JENSAMP-51X

rev03 schematic

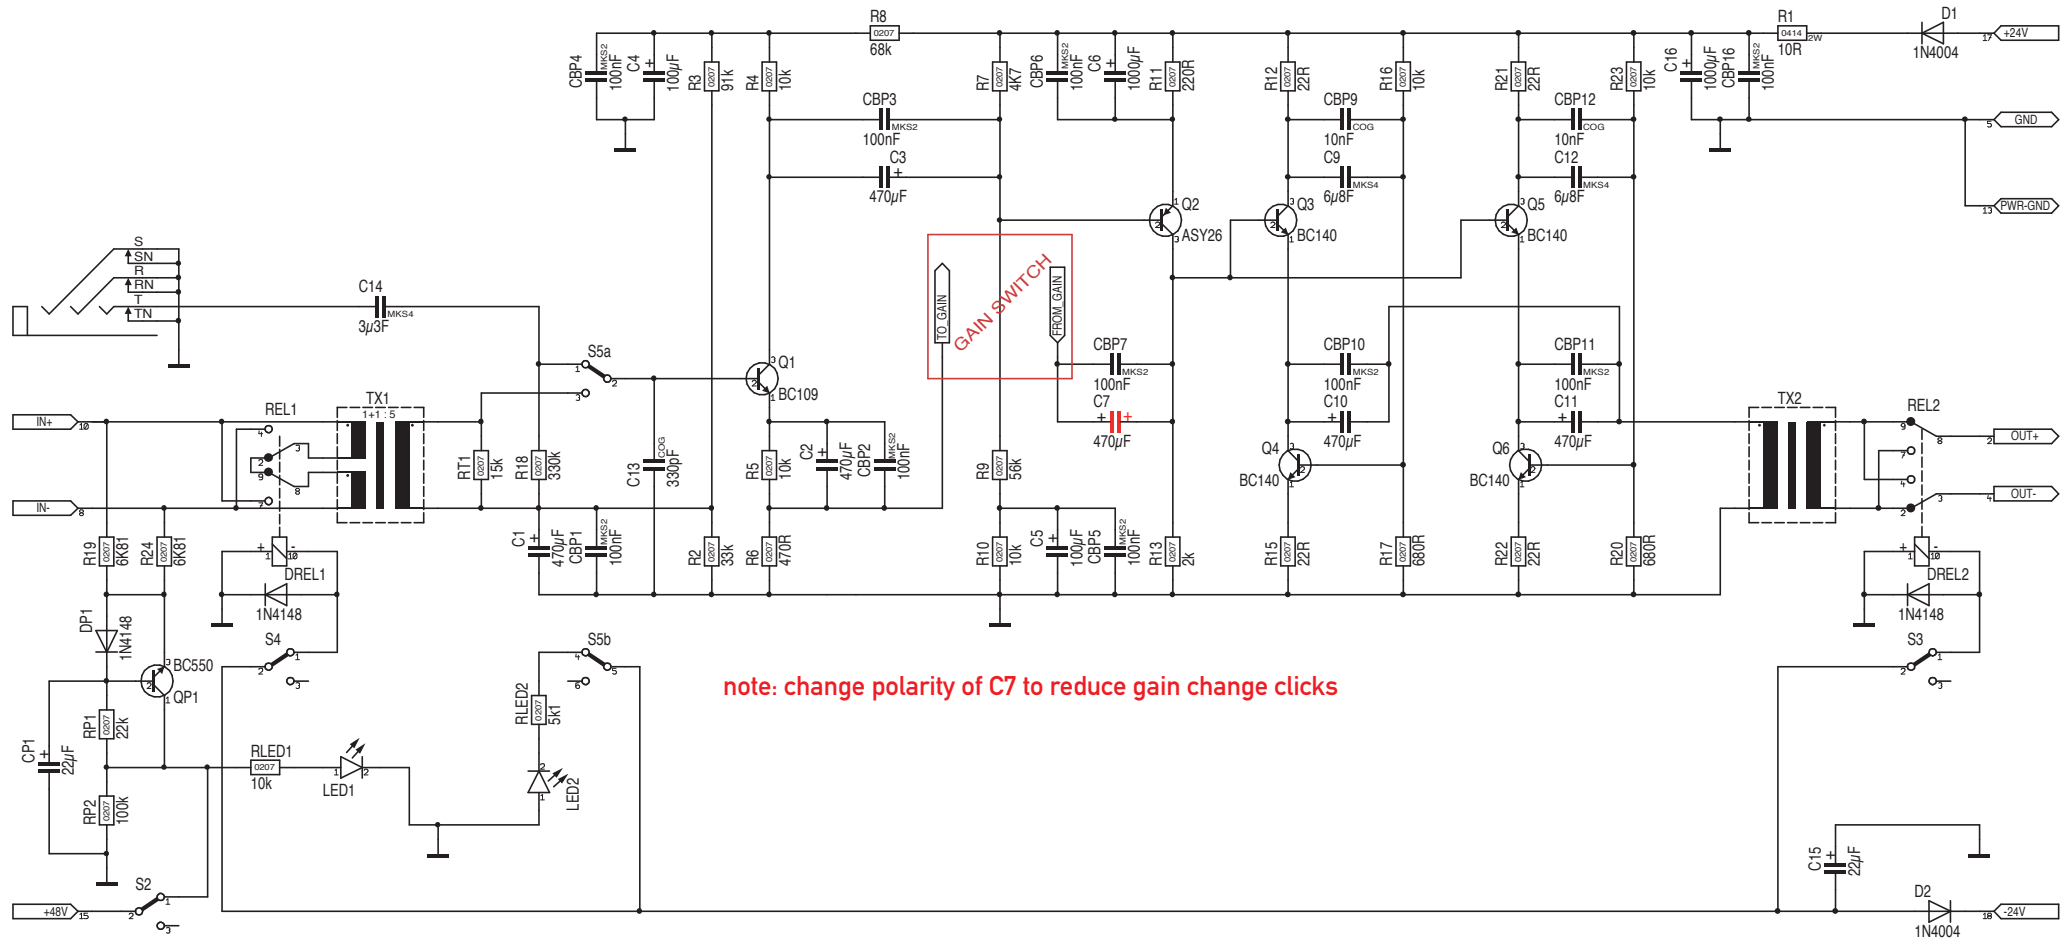
note: change polarity of C7 to reduce gain change clicks
